**Questions and Answers
Request for Proposals
Engineering Services for
61st Street Connector Project**

August 2024

ERSA CONCEPT PLAN

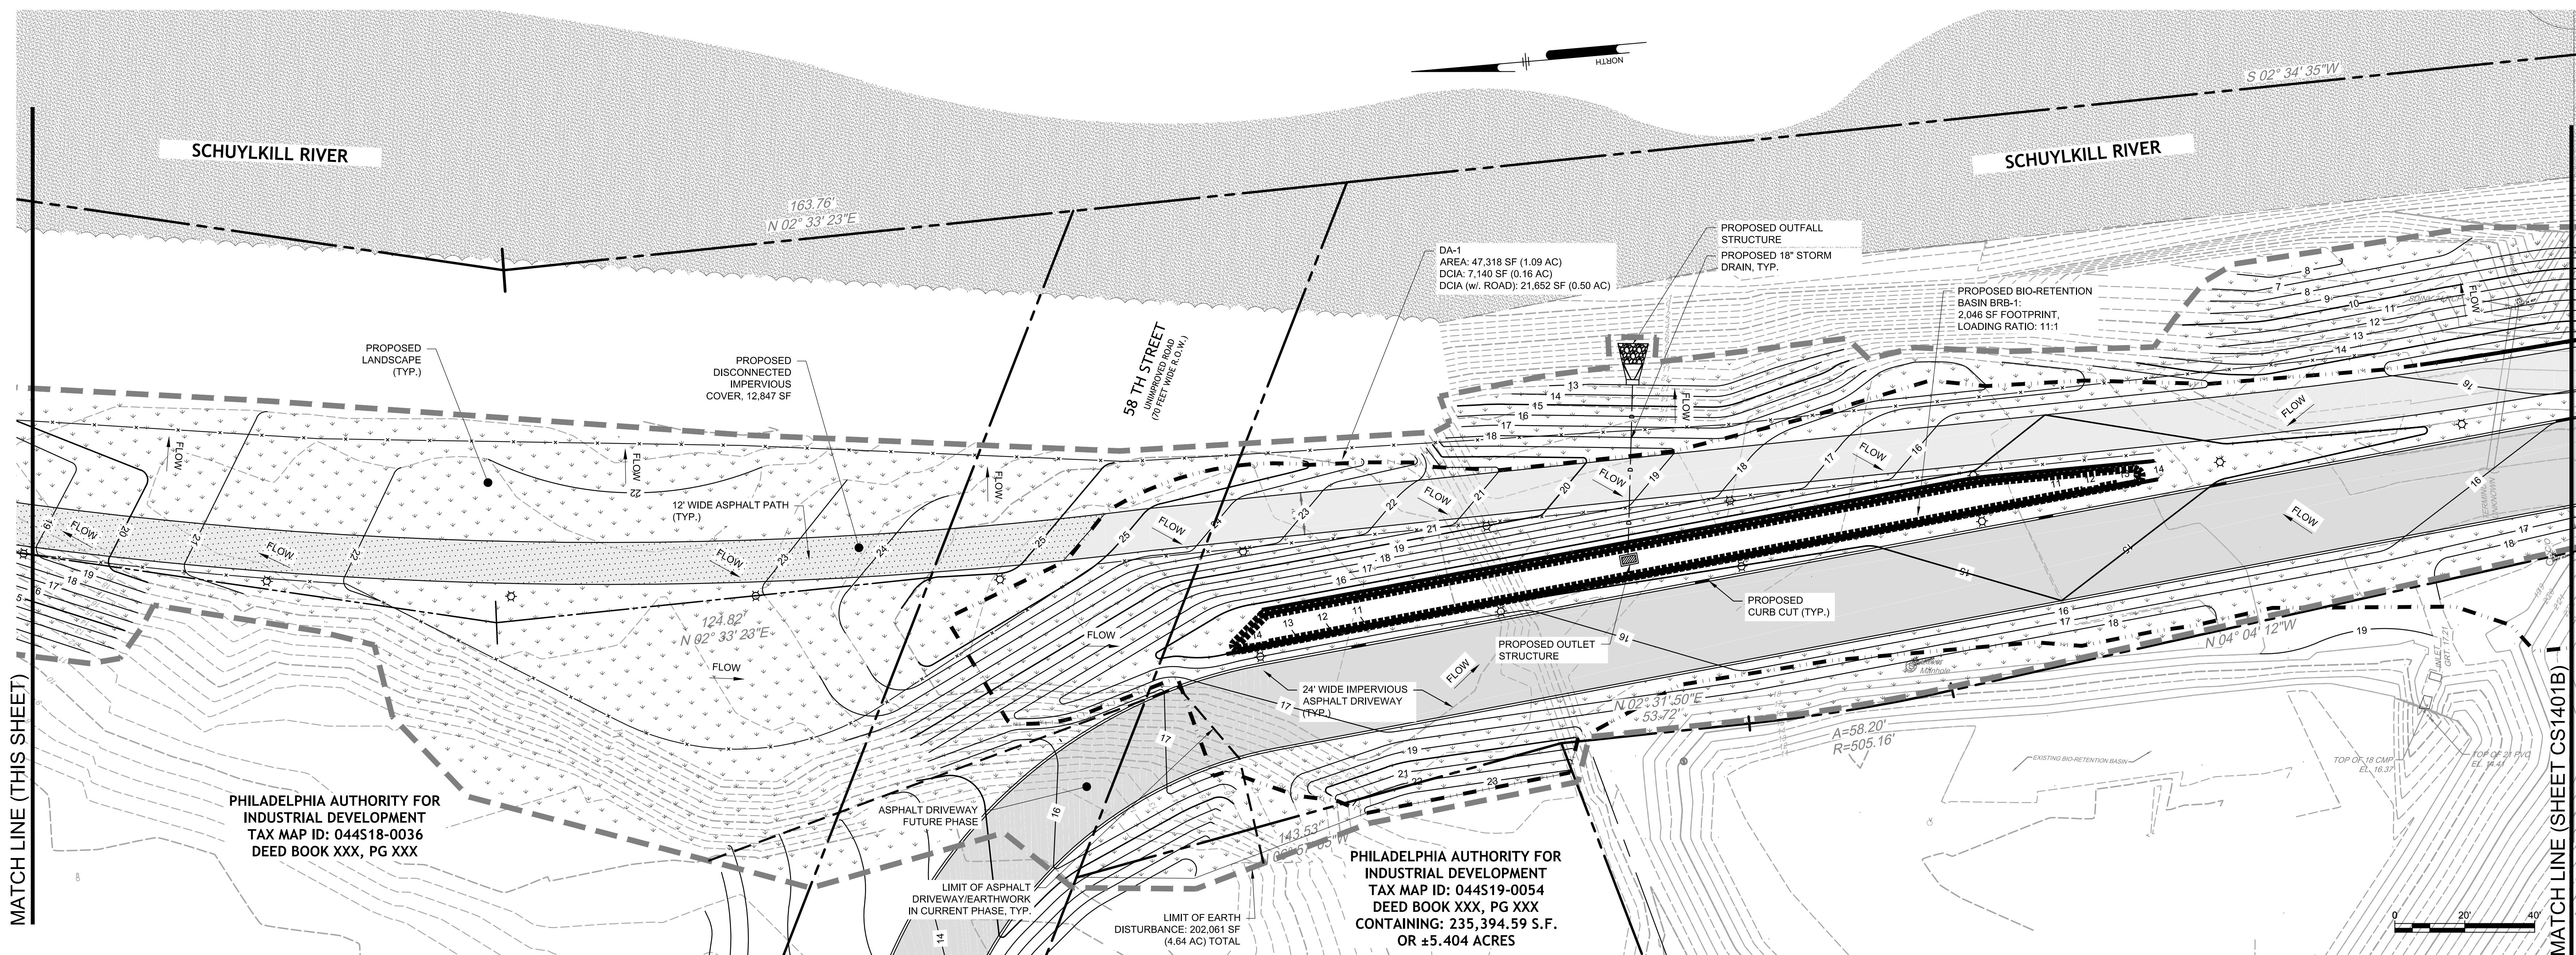
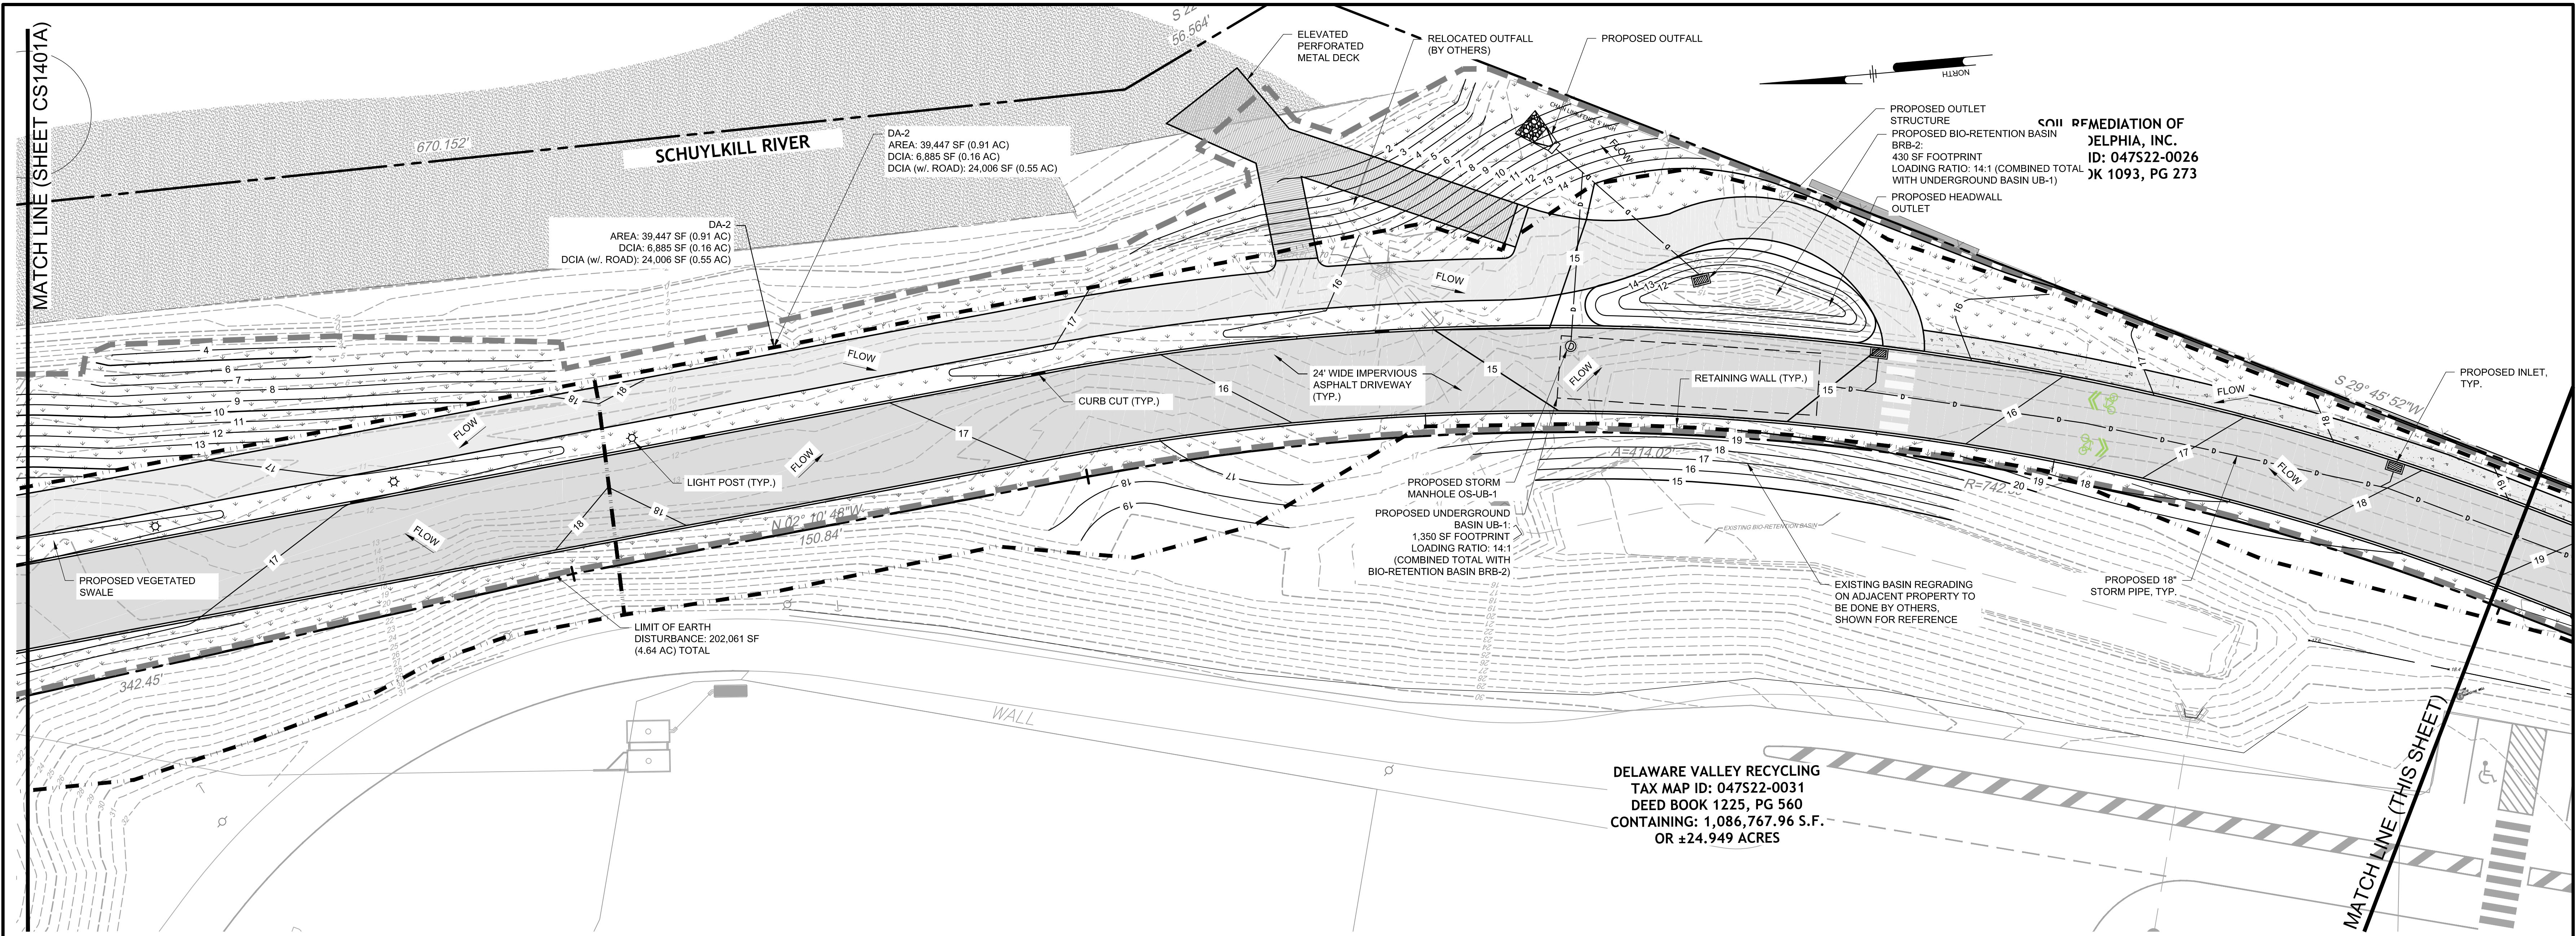
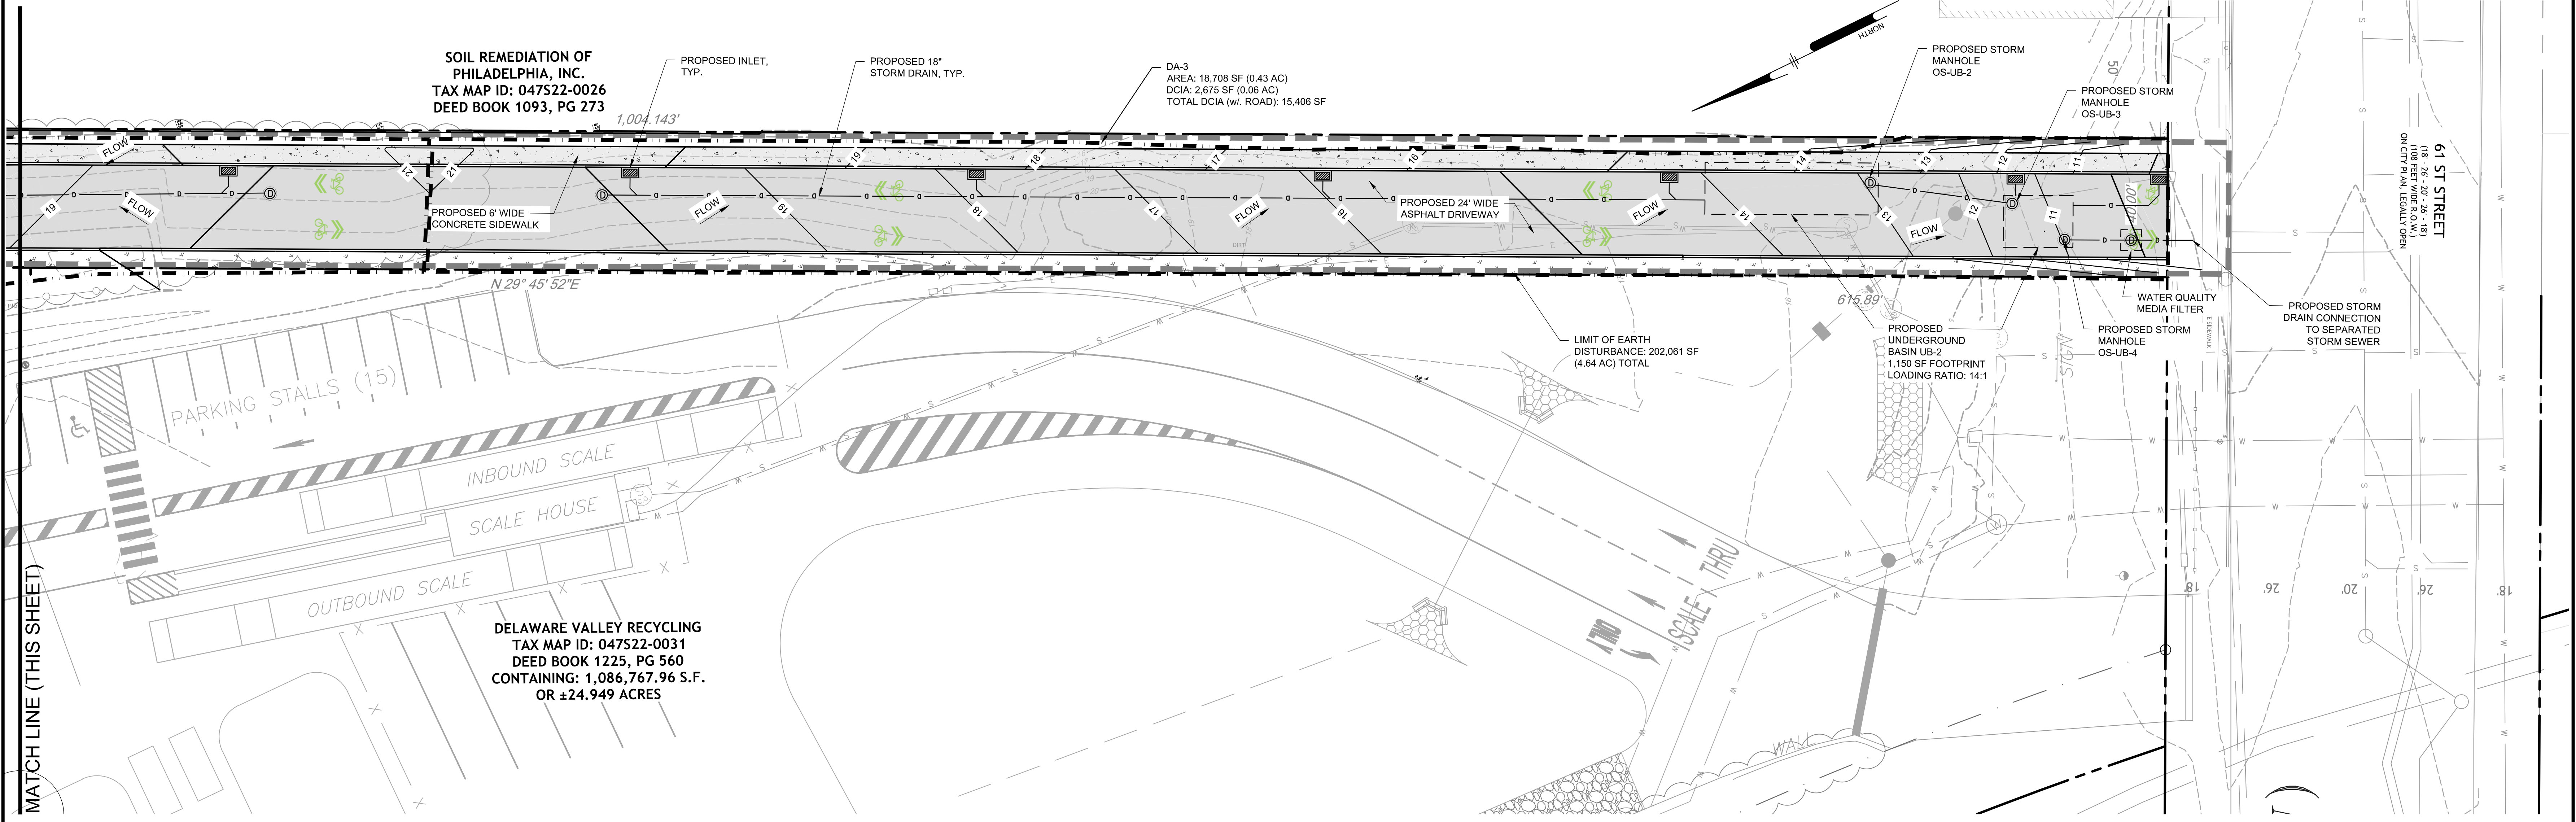
1. **Would it be possible for you to provide a concept plan or sketch showing the general location and extents of the proposed connector?**

2. **The RFP specifies that this is a shared driveway/bike path from 61st Street to 58th Street/the Schuylkill River Trail. After reviewing the Blossom at Bartram's Complete Street Study and the Lower Schuylkill Master Plan, it is not clear where this proposed path is intended to be located.**

3. **It would be helpful to include a map of the project area that defines the specific project extents and includes some commentary on the nature of work within the project limits and some definition of what existing features are to remain. For example, is there a focus on user experience, which would necessitate landscape architecture design? Or is this more of a simple utilitarian design?**

Please see the attached concept plan of the project.

Please see the attached concept plan of the project.

Please see the attached concept plan of the project.
